**In The Drawings:**

Attachment: (2) Replacement Sheets

FIG. 2

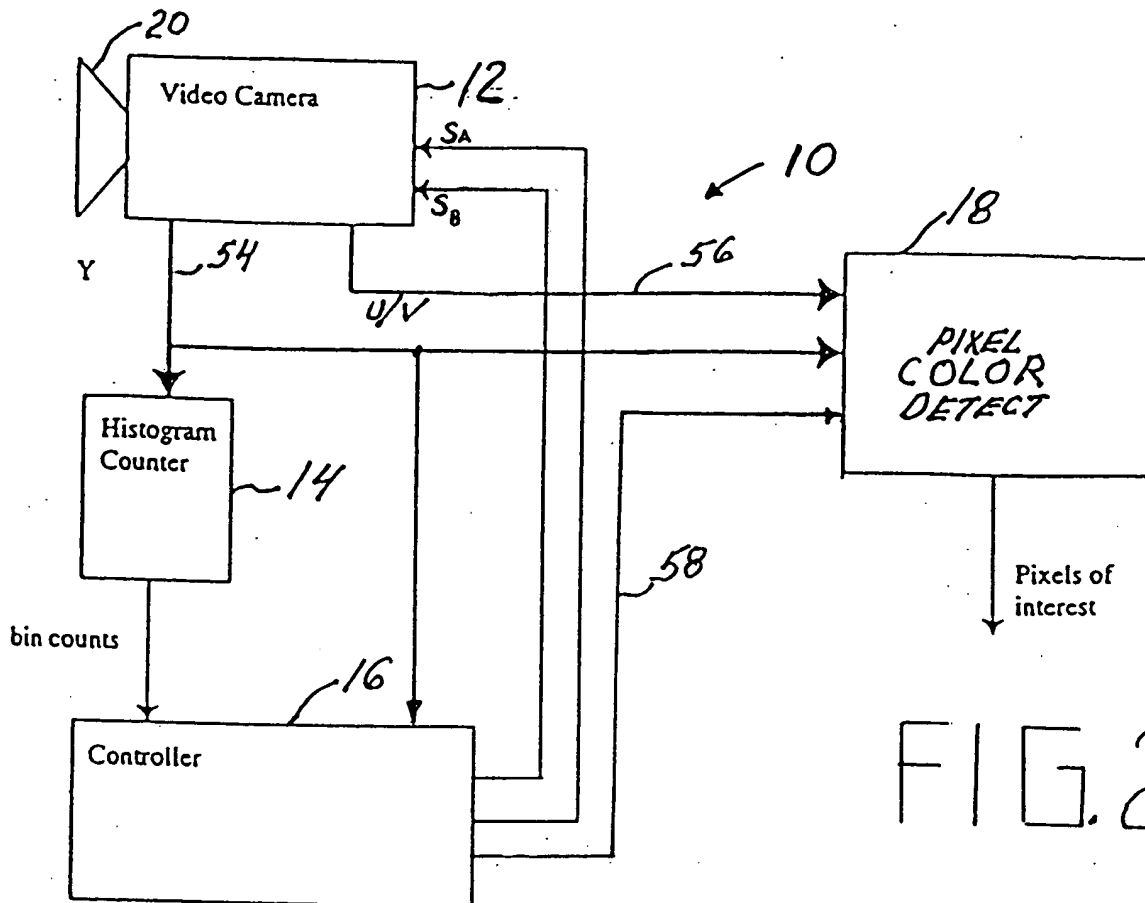
The Examiner objected to the drawings under 37 CFR 1.83(a) for failing to show elements SA and SB as described on page 8 in the specification. Applicant has amended FIGS. 2- 4 to show the elements SA and SB as described in the application. No new matter is added. In light of the submission of the amended drawings, withdrawal of the objection is respectfully requested.
